Item Name: Crosstube Turning Detail

DART AEROSPACE LTD	Work Order:	93997
Description: Crosstube Assembly (205/212/412 High Fwd)	Part Number:	D212-664-141
Inspection Dwg: D212-664-141 Rev: D		Page 1 of 2

DRAWING NO. D212-664-141	TITLE XTUBE ASSY (205/212/412 HI FWD)	REV. D	DART AEROSPACE LTD ENGINEERING ORDER	D.E.O. NO. D212-664-141-D-1	SHEET NO. SHEET 1 OF 2	SCALE NTS
DRAWN	CHECKED	MFG. APPR.	APPROVED	DE APPR.		
DATE 11.04.07	DATE 11.04.11	DATE 11.04.12	DATE 11/04/12	DATE 11.04.12

DRAWING NO. D212-664-141	TITLE CROSSTUBE ASS'Y (205 HI FWD)	REV. D	DART AEROSPACE LTD ENGINEERING ORDER		D.E.O. NO. D212-664-141-D-2	SHEET NO. SHEET 1 OF 1	SCALE NTS
DRAWN <i>UP</i>	CHECKED <i>ASS</i>	MFG. APPR. <i>AB</i>	APPROVED <i>MP</i>		DE APPR. <i>HH</i>		
DATE 11.07.15	DATE 11.07.20	DATE 11.07.21	DATE 11/07/21		DATE 11.07.21

DRAWING NO. D212-664-141	TITLE XTUBE ASSY (205/212/412 HI FWD)	REV. D	DART AEROSPACE LTD ENGINEERING ORDER	D.E.O. NO. D212-664-141-D-1	SHEET NO. SHEET 2 OF 2	SCALE NTS
DRAWN	CHECKED	MFG. APPR.	APPROVED	DE APPR.		
DATE 11.04.07	DATE 11.04.11	DATE 11.04.12	DATE 11/04/12	DATE 11.04.12

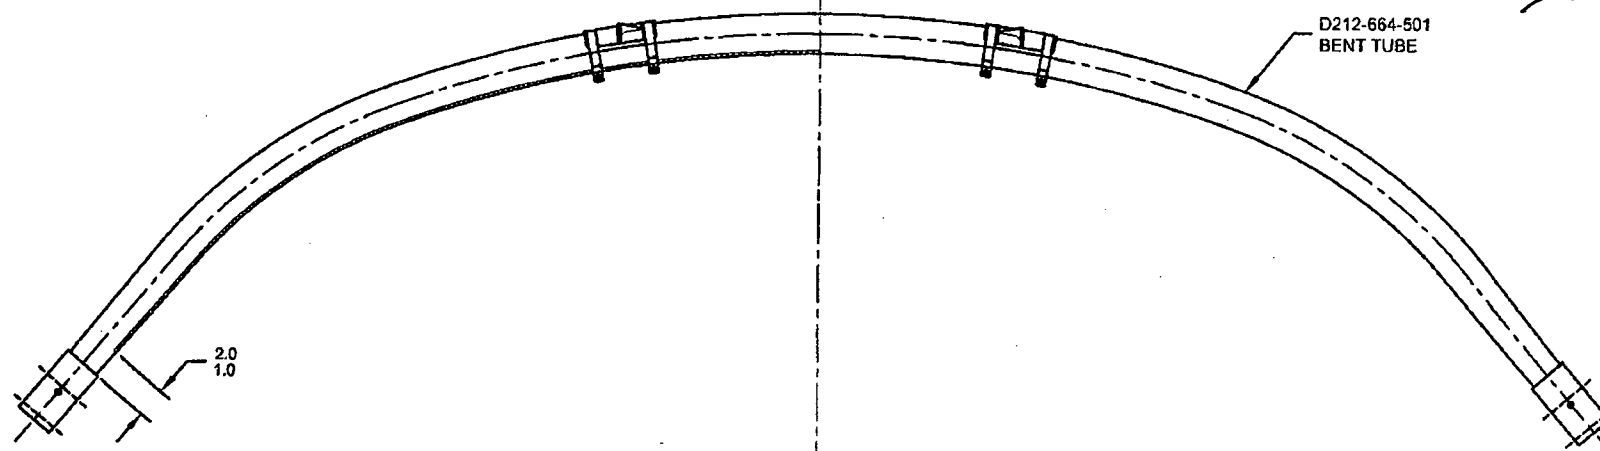
PURPOSE:

ADD AN INSPECTION WINDOW TO UNDERSIDE OF CROSSTUBE.

NOTES 2 OF SHEET 1 IS AMENDED AS FOLLOWS:

- 2) FINISH: CHEMICAL CONVERSION COAT PER DART QSI 005 4.1
PRIME INSIDE AND OUTSIDE PER DART QSI 005 4.2
MASK UNDERSIDE OF CROSSTUBE AS SHOWN (HATCHED AREA) AND
PAINT OUTSIDE PER DART QSI 005 4.2
REMOVE MASKING AND APPLY CLEAR COAT

- 2) FINISH: CHEMICAL CONVERSION COAT PER DART QSI 005 4.1
PRIME INSIDE AND OUTSIDE PER DART QSI 005 4.2
PAINT OUTSIDE PER DART QSI 005 4.2

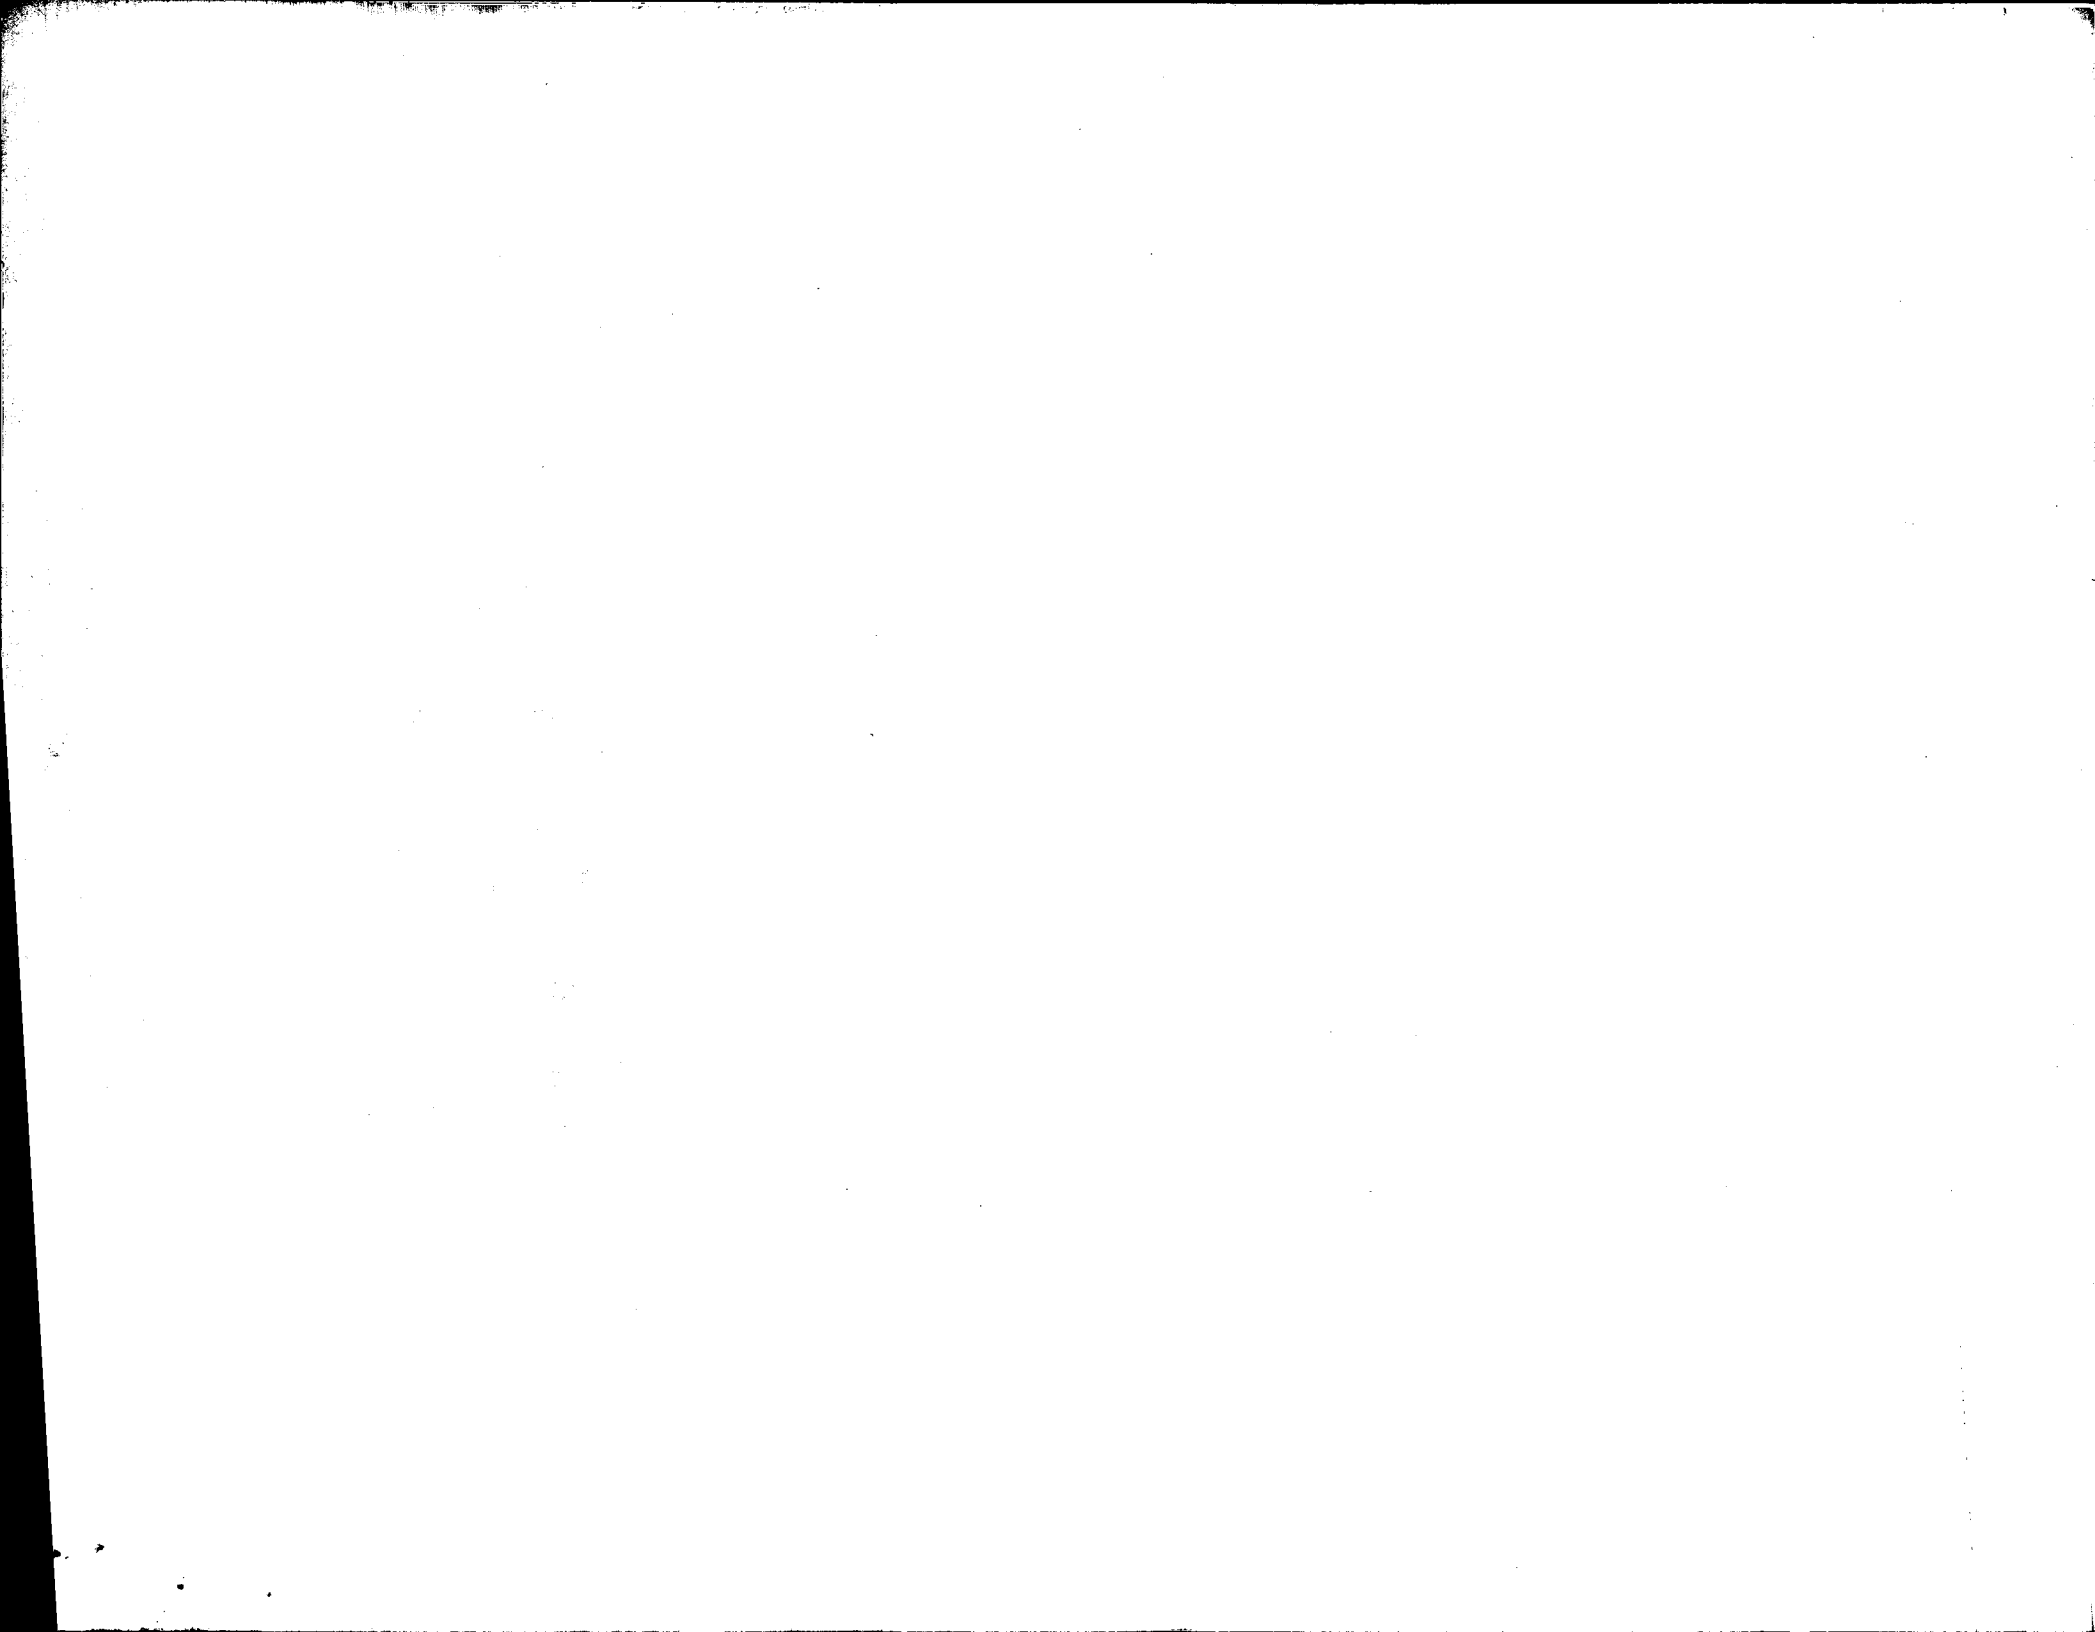
PURPOSE:

REPLACE MAGNOBOND WITH PROSEAL.

Item	Qty -141	Qty -141B	Part Number	Description
7	A/R	A/R	PROSEAL 890 B-2	SEALANT, AMS-S-8802 CLASS B-2

7	A/R	A/R	MAGNOBOND 6398	ROCKWELL SPECIFICATION RBO-120-023 ADHESIVE (TEXTRON/BELL SPEC. 299-947-100, TYPE II, CLASS 2 ADHESIVE)
---	-----	-----	----------------	---

NOTE 12 & 15, SHEET 1 IS AMENDED AS FOLLOWS:

- 12) TO INSTALL D2893-1 SUPPORT: ABRASE MATING SURFACE OF SUPPORT AND CROSSTUBE WITH 180-GRIT SANDPAPER AND REMOVE RESIDUE WITH MEK (OR EQUIVALENT). APPLY A 0.04" TO 0.07" THICK LAYER OF PROSEAL 890 CLASS B-2 (OR AMS-S-8802 CLASS B-2) SEALANT TO MATING SURFACE OF SUPPORT.
- 15) TORQUE CLAMPS 80 TO 100 IN-LB. ENSURE AT LEAST 1.5 THREADS SHOWING IN SAFETY AND THAT NUT HAS NOT BOTTOMED-OUT AFTER TORQUING. **PRIOR TO PACKAGING, RE-CHECK TORQUE ON CLAMPS AFTER PROSEAL 890 SEALANT HAS CURED FOR 72 HOURS.**

- 12) INSTALL D2893-1 SUPPORT USING 0.03" TO 0.06" THICK LAYER OF MAGNOBOND 6398 TO THE SURFACE OF D2893-1 THAT WILL BE IN CONTACT WITH THE CROSSTUBE PER QSI 015. LET CURE FOR 12 HOURS AFTER INSTALLATION AND PRIOR TO PACKAGING.
- 15) TORQUE CLAMPS 80 TO 100 IN-LB. ENSURE AT LEAST 1.5 THREADS SHOWING IN SAFETY AND THAT NUT HAS NOT BOTTOMED-OUT AFTER TORQUING.
